Bid Package 2 | Addendum No. 4
for
Construction of
St. Croix County Health Center Additions and Renovation
Project No. 146038

Date: July 20, 2015

PROJECT: Bid Package # 2
St. Croix County Health Center Additions and Renovation
New Richmond, WI

M202

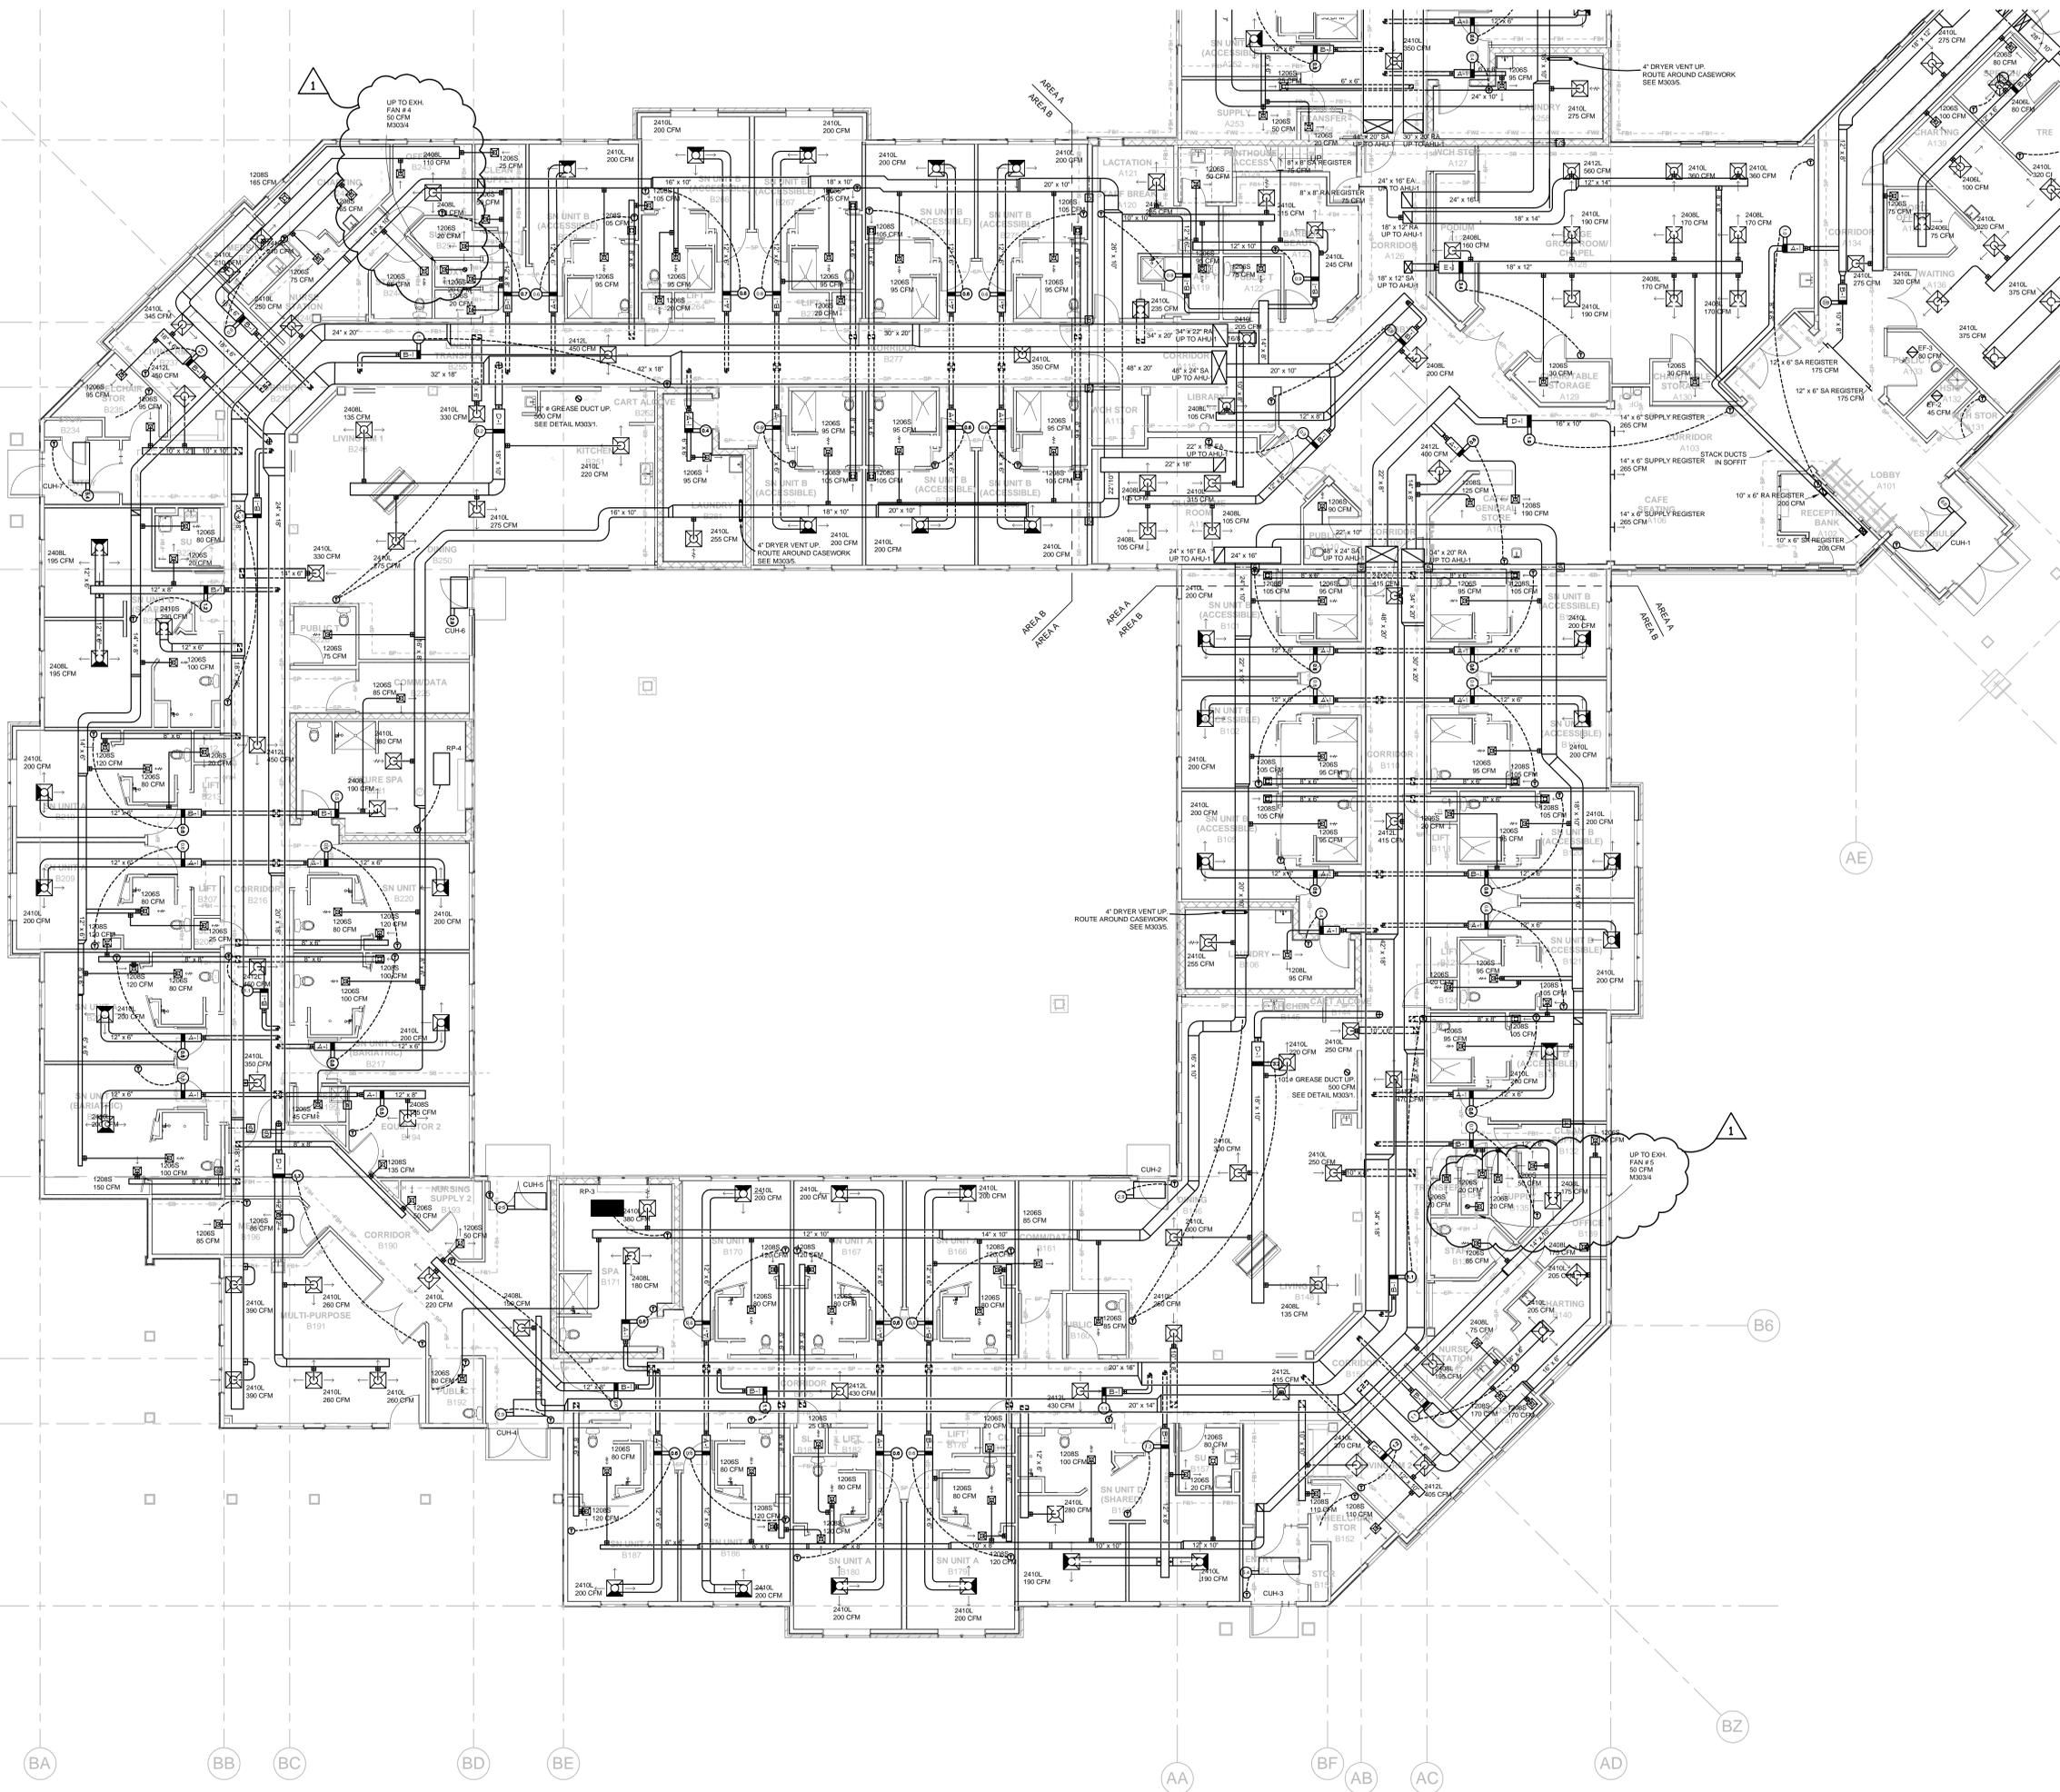
Add note and duct to EF-5 (Oxy B256)
Add note and duct to EF-6 (Oxy B134)
